#### APPEAL SUMMARY

**Status:** Decision Rendered - Reconsideration of ID 24228

<b>Appeal ID:</b> 24416	<b>Project Address:</b> 915 NE Schuyler St
<b>Hearing Date:</b> 11/25/20	<b>Appellant Name:</b> Hali Knight
<b>Case No.:</b> B-018	<b>Appellant Phone:</b> 971-352-3935
<b>Appeal Type:</b> Building	<b>Plans Examiner/Inspector:</b> Steven Mortensen, Kent Hegsted, Ed Marihart
<b>Project Type:</b> commercial	<b>Stories:</b> 9 <b>Occupancy:</b> R-2 <b>Construction Type:</b> 1-A
<b>Building/Business Name:</b>	<b>Fire Sprinklers:</b> Yes - Throughout
<b>Appeal Involves:</b> Alteration of an existing structure, Reconsideration of appeal	<b>LUR or Permit Application No.:</b> 20-185703-CO
<b>Plan Submitted Option:</b> pdf [File 1] [File 2] [File 3] [File 4] [File 5]	<b>Proposed use:</b> Residential

## DAHLKE MANOR RENOVATION

Sheet Title:  
CODE ANALYSIS

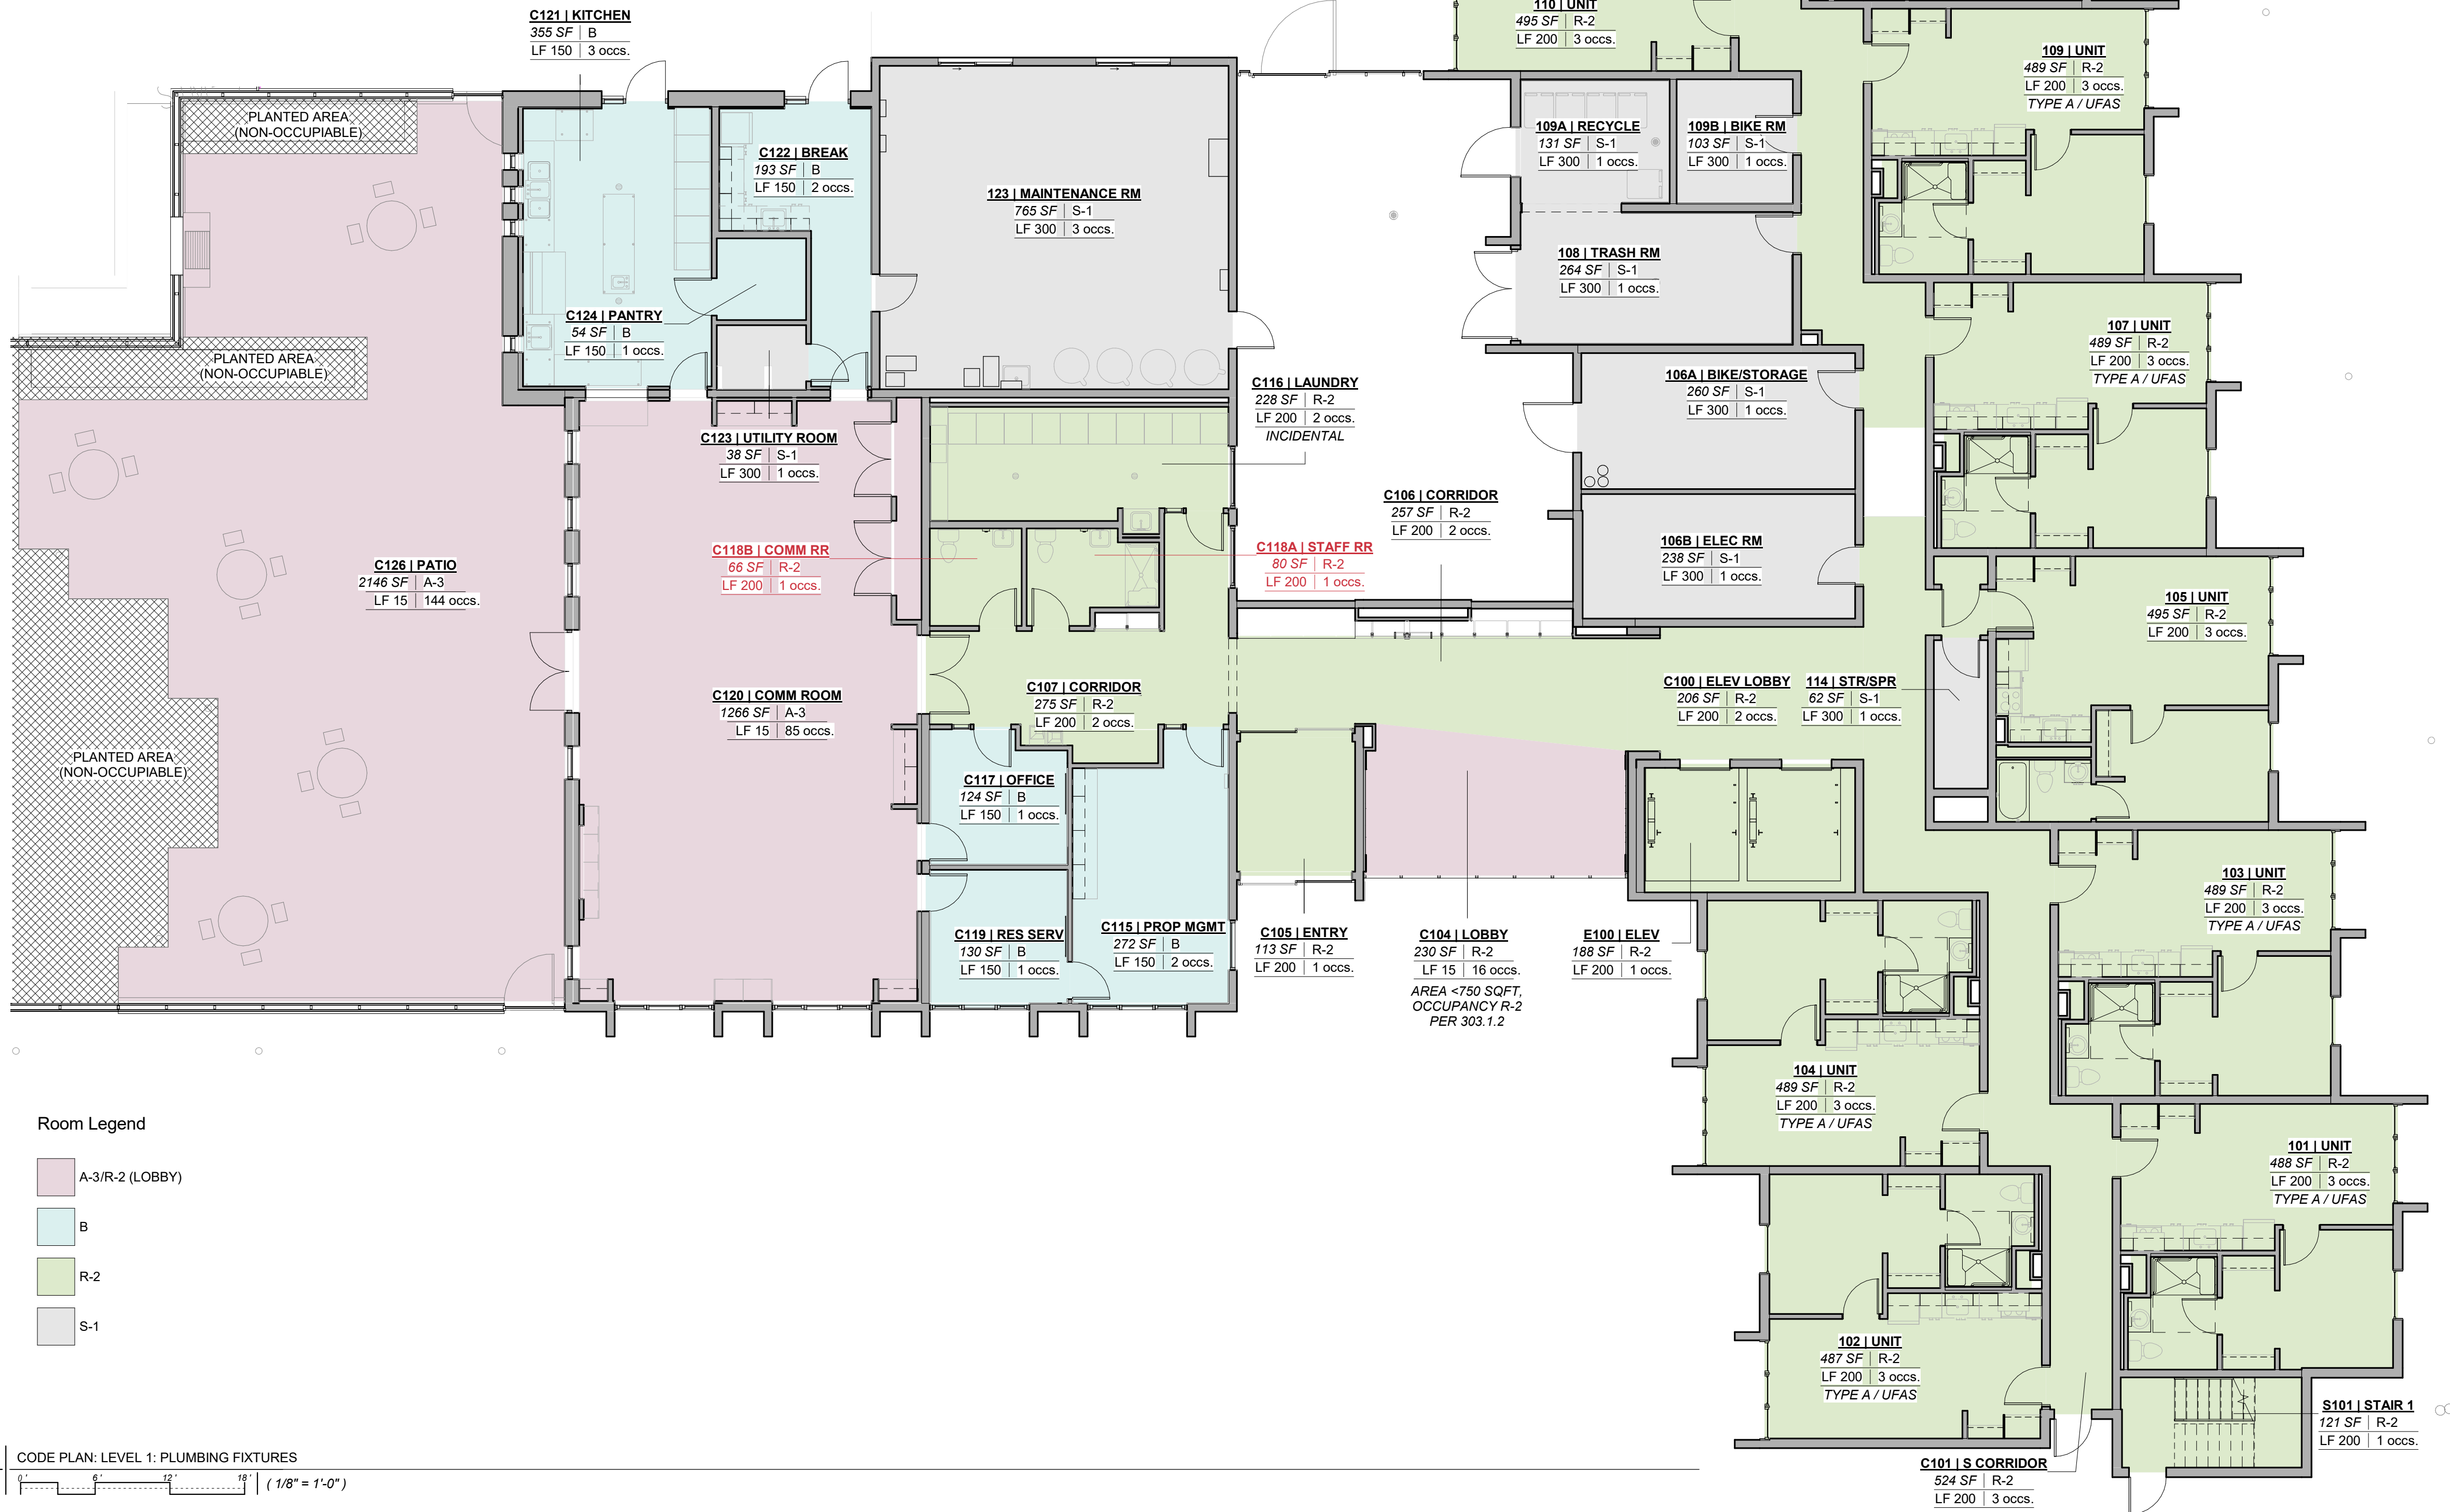
The building is a concrete block high rise, Type 1A construction in accordance with current code OSSC 2019. Reference code analysis sheet G006 and G007 for the building's compliance to current code requirements. The building meets the life safety requirements of two enclosed fire protected egress stairs, has no dead-end corridors, and is fully sprinklered throughout in accordance with NFPA 13. Exit separation distance, exit access travel distance, egress doors, sizing of corridors, and fire protection requirements all meet current code requirements.

**3. Removal of building from Chapter 13 status: Granted provided Life Safety check sheet items are satisfactorily addressed prior to approval of life safety plan review.**

# FIRE SPRINKLER PLAN

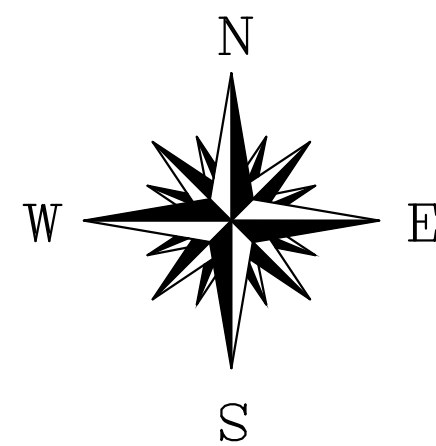
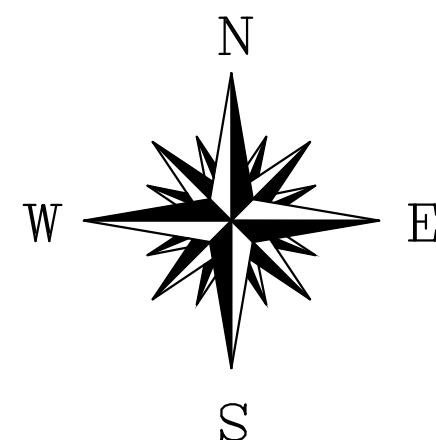
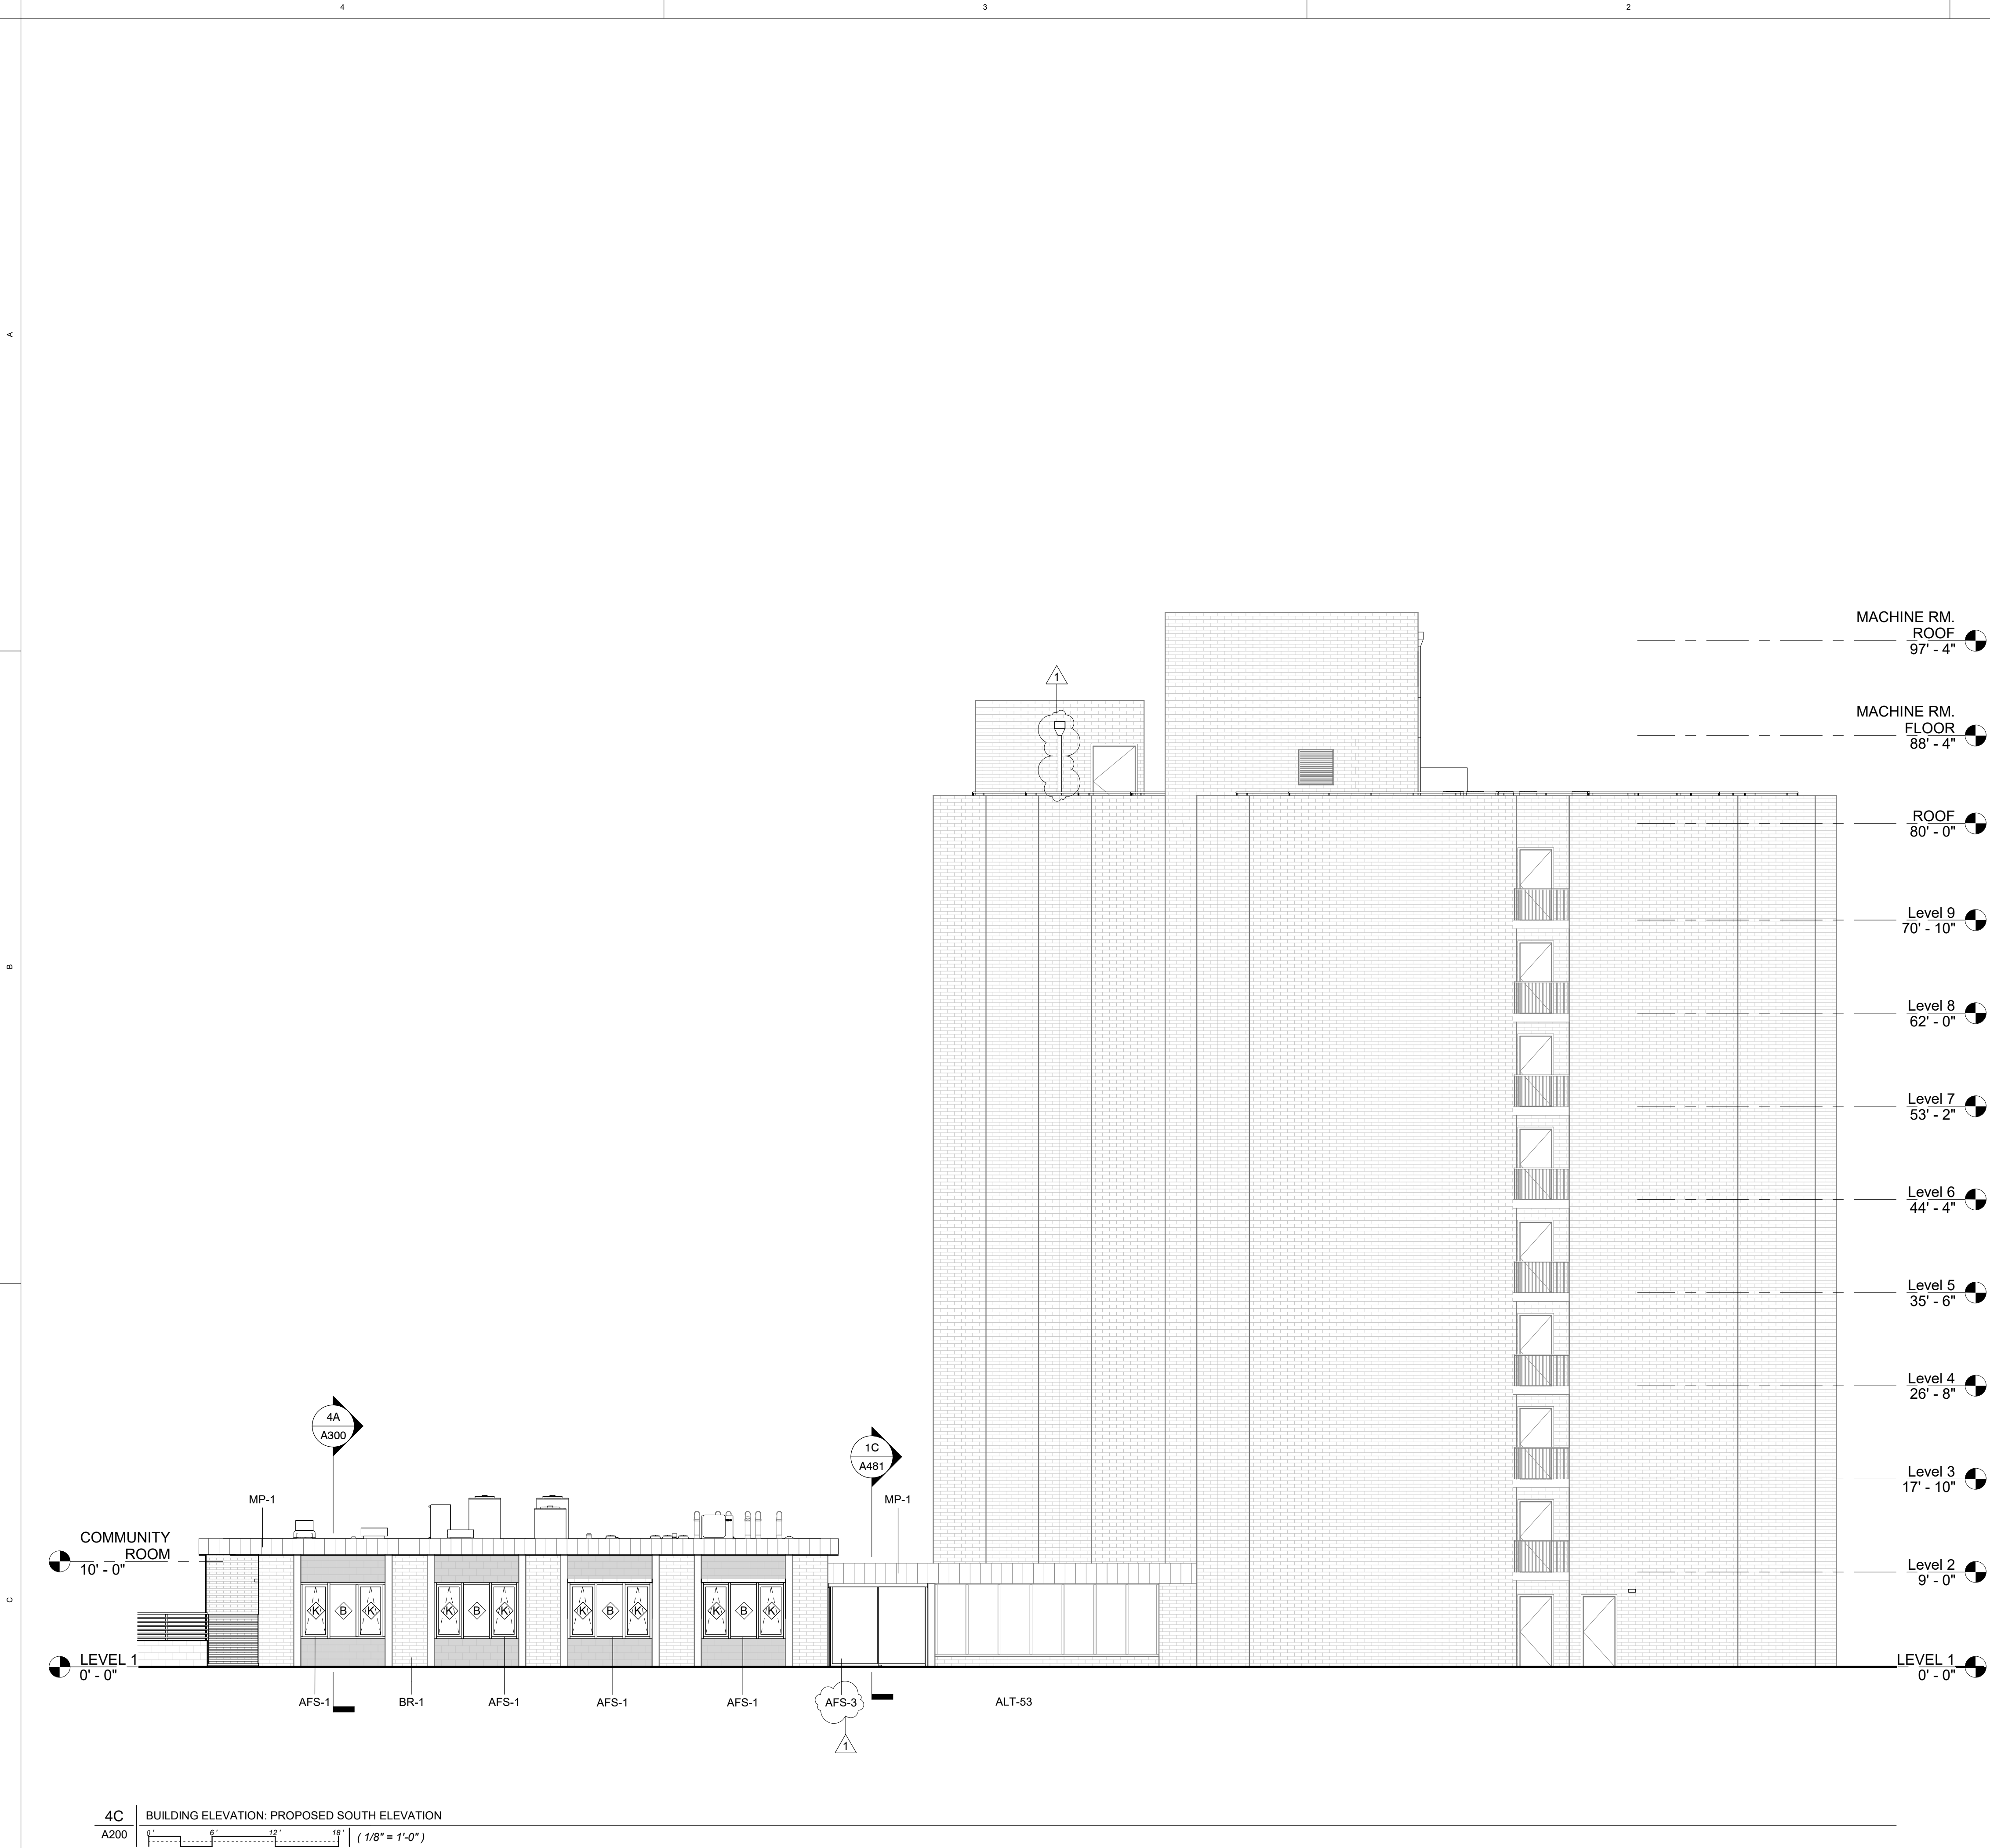
Reconsideration Text: Reference submitted sheets A150 and A151 RCP Plans that show the existing and proposed location of sprinkler heads throughout the building. Previously submitted drawings did not show all locations of existing sprinkler heads throughout the building, only those in scope for new work. The scope of work will replace existing sprinkler heads and add new sprinklers in common areas and the new addition. The building will be fully sprinklered throughout and meets NFPA 13.

Reconsideration Text: Reference submitted sheets A150 and A151 RCP Plans that show the existing and proposed location of sprinkler heads throughout the building. Each unit is fully sprinklered with 6-7 sprinkler heads and meets NFPA 13.
